Attachment 2
Report No. DS-2023-0096
232 Cameron Crescent
Page 1 of 1

KESWICK LIGHT HOUSE RESIDENTIAL DEVELOPMENT

**Re: 1st Submission- Official Plan Amendment 02.207 & Zoning By-law Amendment 03.1180
(Keswick Lighthouse Developments)
230, 232, 236 & 240 Cameron Crescent, Keswick
Lots 1 – 15 and Block A and Doreda Drive, Registered Plan 447 / Lot 5 and Part of Lots
6 and 8, Registered Plan 170
Town of Georgina
Regional File Nos.: LOPA.23.G.0063 & ZBA.23.G.0102**

1st Submission- Official Plan Amendment 02.207 & Zoning By-law Amendment 03.1180 (Keswick Lighthouse Developments)

Site Plan

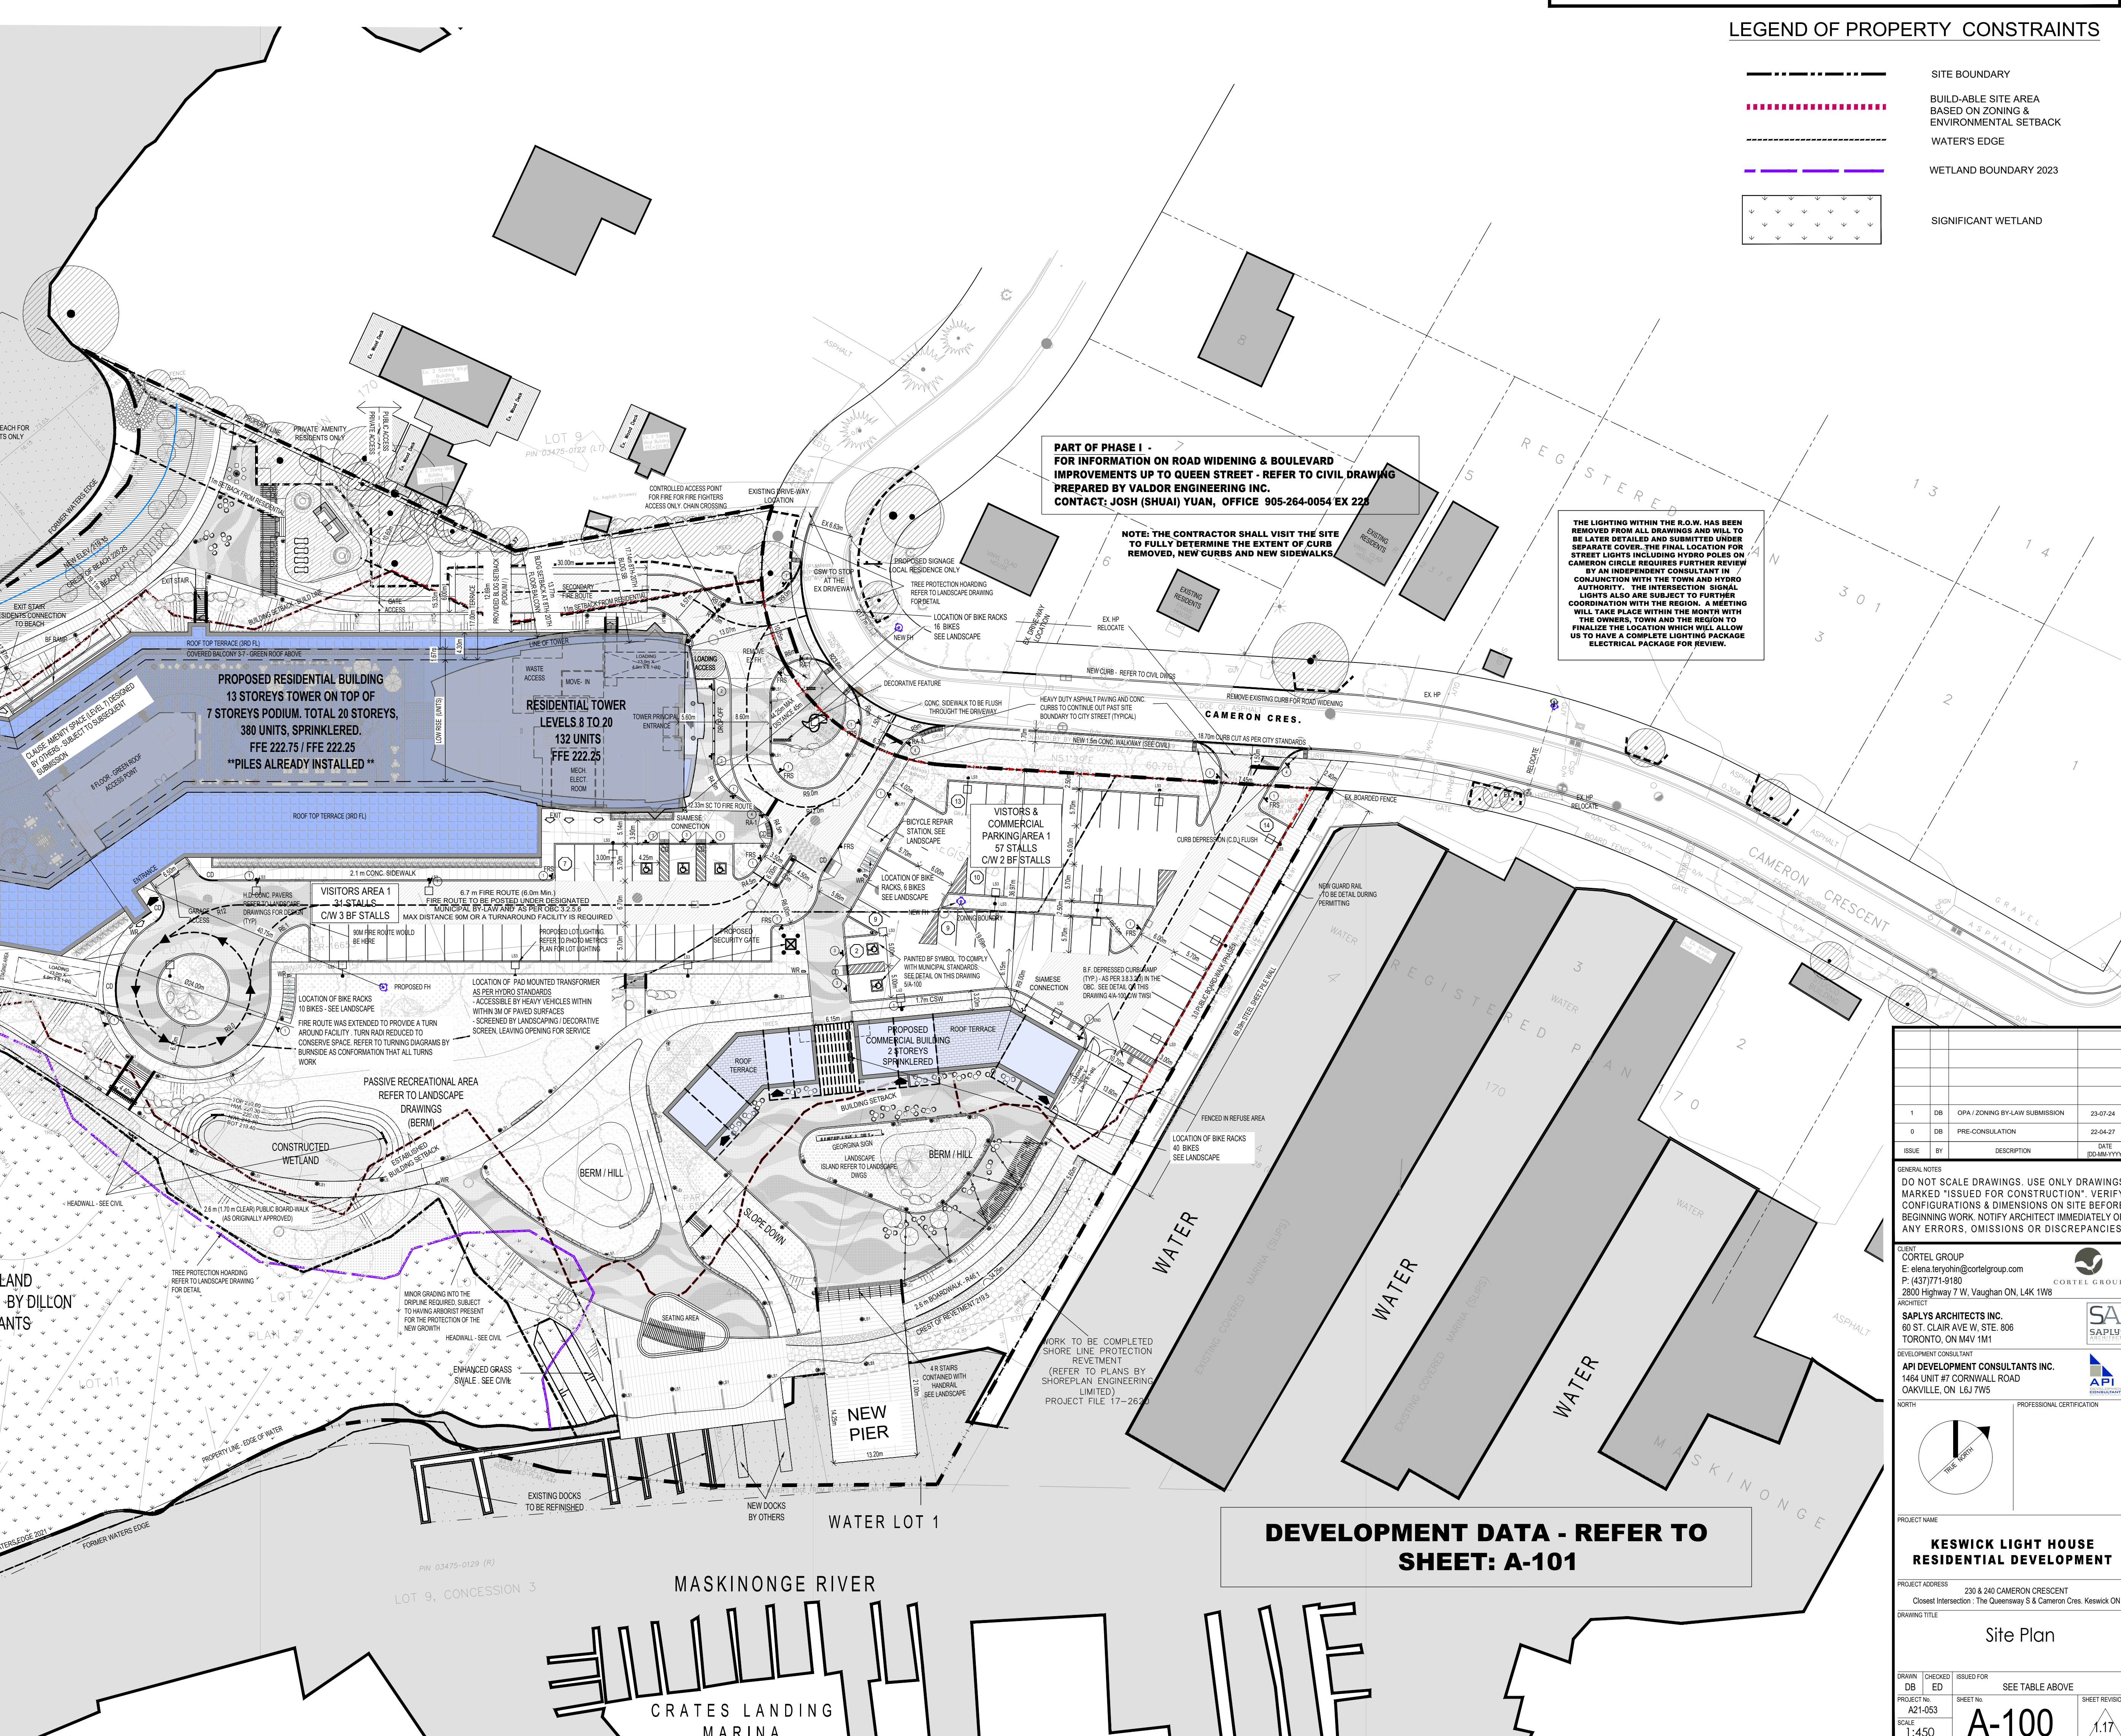
4. The Development Plan and Grading Plan appear to include construction of a new pier as part of the application. Figure 4 of the EIS does not show this feature, nor does the report include an assessment of the impacts of this structure on fish and fish habitats. An assessment of the impacts of all in-water and shoreline work on aquatic habitats should be provided, including potential impacts associated with the pier, new or upgraded docks and the shoreline stabilization measures.

8. The boardwalk should be realigned to avoid areas where it encroaches into the wetland. In addition, the residential building and driveway should be shifted out of the wetland buffer. A boardwalk may be permissible closer to the outer limit (i.e., outer 5 m) of the wetland buffer, subject to approval by the LSRCA. The wetland buffer should be naturalized. Details of buffer naturalization should be provided on a Landscape / Restoration Plan to be developed during detailed design.

Section 7.0 Site Plan Review:

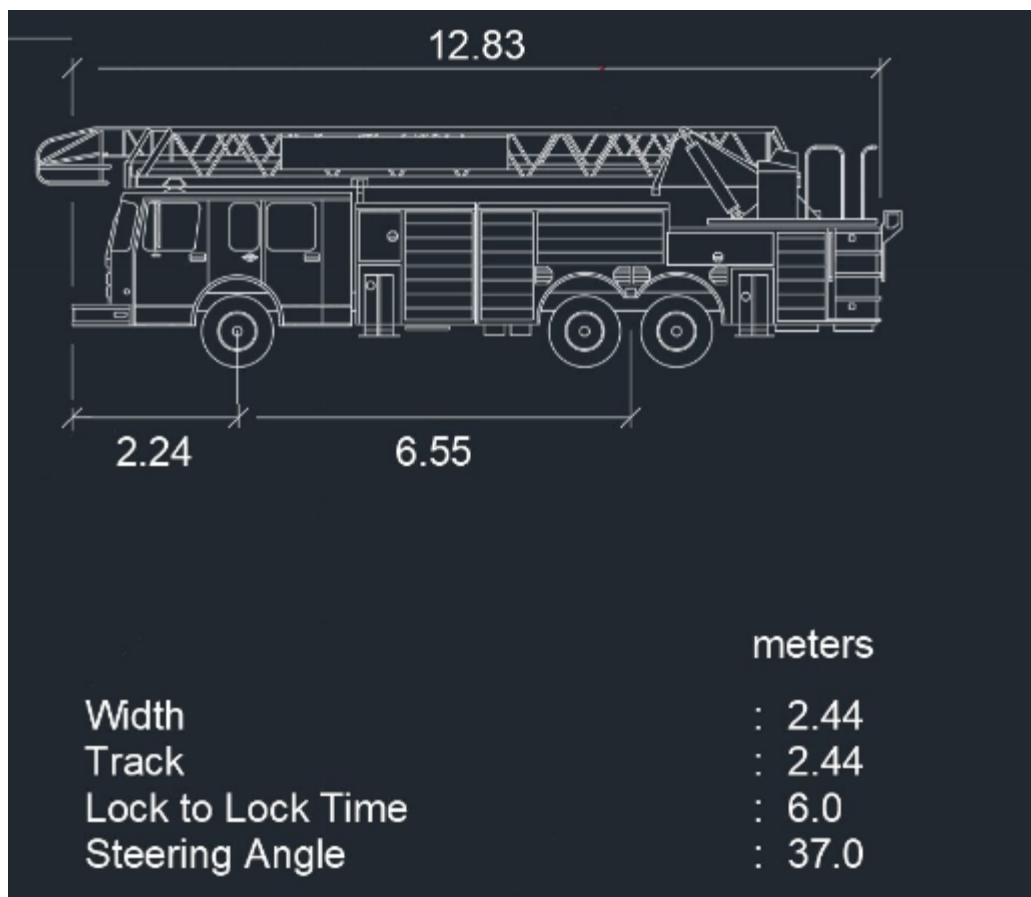
3. The access analysis conducted by Burnside to confirm fire truck access was carried out with a Pumper Fire Truck (length of 10.08 m and wheelbase of 5.08 m), which is considerably shorter than an Aerial Fire Truck and therefore does not represent the largest fire truck that may need to access the site. The Town's standard fire truck design vehicle is shown in the figure below (length of 12.83 m and wheelbase of 6.55 m). We recommend that Burnside update the fire truck access analysis using this design vehicle.

SBM conducted cursory vehicle path analysis with the Town's standard size of fire truck and found that the turnaround circle at the parking garage entrance is not quite large enough to allow the fire truck to circulate around the circle. It appears increasing the turnaround circle diameter to a minimum of 26 m would be needed.

4. Burnside's loading space access analysis for the residential building was conducted with a Medium Single Unit (MSU) truck (10 m in length). Since it is not uncommon for a Heavy Single Unit (HSU) truck (11.5 m in length with longer wheelbase) to be used for residential moving and deliveries (e.g. furniture/appliances), we recommend that Burnside include HSU access analysis for the residential building to determine whether site plan modifications may be required to accommodate HSU truck movements, or if special signage may be necessary to prohibit movements that will be problematic.

the parking area gate due to the bend at the gate location (see screenshot below). This suggests that modifications to the turnaround circle and exit gate lane should be considered or signage should be installed to prohibit HSU trucks from entering the parking area (i.e. trying to use the rear/garage loading spaces).
